N1092B-01

Modification Recommended Service Note

N1092B DCA-M Sampling Oscilloscope (Dual Optical Channel)

Serial Numbers: US00000000-US57229999

Figure 1 Updated overlay - should say 1.4 Vpp Max

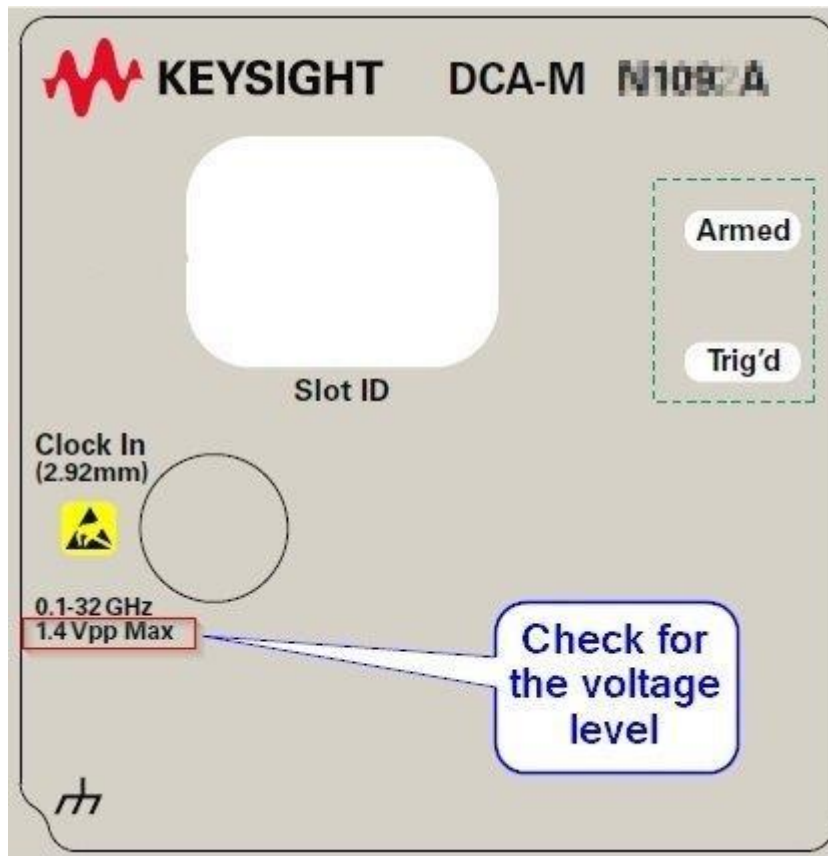
In May 2018, the clock's input port maximum signal voltage changed from 2.0 Vp-p (old value) to 1.4 Vp-p (new value). This is very sensitive circuitry and this change provides additional margin to reduce risk of damage to the instrument.

New instruments shipping after this change has the new left front panel overlay with this updated information, see Figure 1 below.

For instruments with the old overlay, when they are shipped back to Keysight for calibration or repair, we recommend replacing the instrument's left front overlay if it shows 2 Vp-p maximum (old value). In addition, a customer letter should be sent along with the instrument to explain why we updated the instrument with the new overlay.

If the front left panel overlay shows 2 Vp-p (old value), remove the old overlay and replace it with the new overlay that shows 1.4 Vp-p (new value). If the customer has added any asset tags, or other customer information to the old left front panel overlay, it is recommended to send back the old overlay to the customer after it has been removed.
